Docket Item # 7
BAR CASE # 2009-0015

BAR Meeting
April 1, 2009

ISSUE: Demolition/Encapsulation
APPLICANT: Patrick Camus for Ken and Esther Carpi
LOCATION: 117 South Lee Street
ZONE: RM/Residential

Figure 7. Proposed demolition in elevation.

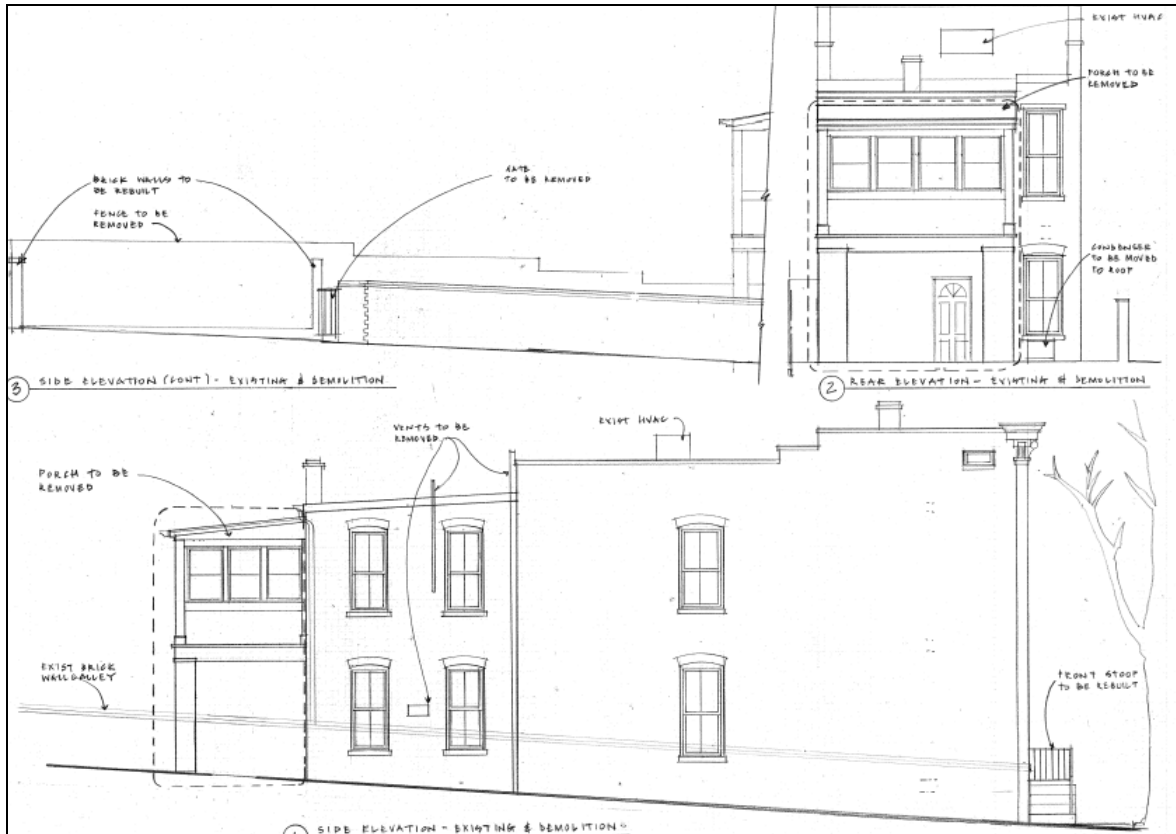
The applicant is requesting approval of a Permit to Demolish/Encapsulate in order to construct a two-story rear addition at 117 South Lee Street. The applicant proposes to demolish an existing enclosed porch structure on the rear (west) elevation. A new two-story addition will replace this addition. The rear (west) elevation of the brick rear ell has already been encapsulated/demolished with the existing addition, a surface area measuring approximately 315 square feet. Additional encapsulation will occur as the proposed addition will encapsulate approximately two feet of the historic rear ell, an area of approximately 42 square feet. Originally, the applicant proposed to demolish a brick flue on the rear ell. In the revised submission the applicant will retain the brick flue.

Upon review of the original submission, Staff was concerned about the proposed demolition of the historic garden wall on the alley elevation and the brick flue on the rear ell and found that Criteria 5 and 6 were applicable. However, the revised scheme no longer proposes any demolition, encapsulation or alteration to this historic garden wall or flue, thereby addressing Staff’s concerns. Staff has no objection to the demolition of the non-historic brick wall adjacent to the parking area or the dilapidated wood fence, The brick wall at the rear (west) property line also appears to possibly be historic yet has been so significantly altered and patched (with CMU in one part) that it does not retain its integrity. Staff notes that this wall does have some historic brick and advises that the historic brick should be retained and reused on the site.

1. That the applicant should reuse all historic brick on the altered garden wall located at the west (rear) property line.
2. *The applicant/developer shall call Alexandria Archaeology immediately (703-838-4399) if any buried structural remains (wall foundations, wells, privies, cisterns, etc.) or concentrations of artifacts are discovered during development. Work must cease in the area of the discovery until a City archaeologist comes to the site and records the finds.

Figure 8. Proposed demolition in plan.

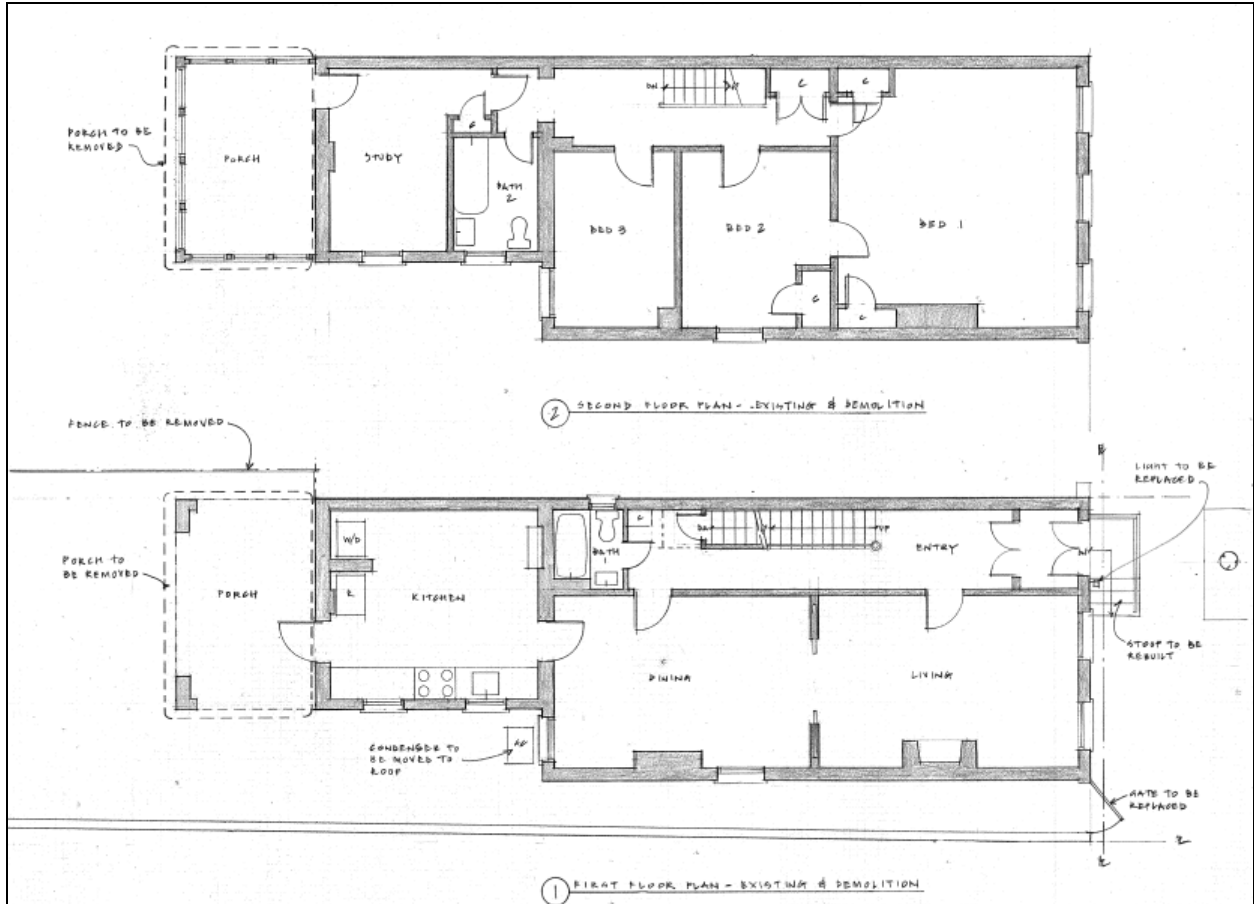
The applicant also proposes to demolish the existing front stoop in order to rebuild and reorient the front stoop. The applicant proposes to remove a deteriorated wood fence on the north property line and the non-historic brick wall adjacent to the parking area.

In the original submission, the applicant proposed to demolish a 3 foot wide portion of the historic brick wall on the alley (south) elevation to accommodate a new gate opening as well as raise the historic brick garden wall approximately 18 inches, thus encapsulating the entire top surface of the brick wall. In the revised submission, the applicant no longer proposes any demolition, encapsulation or alterations to the existing historic garden wall that is adjacent to the alley.
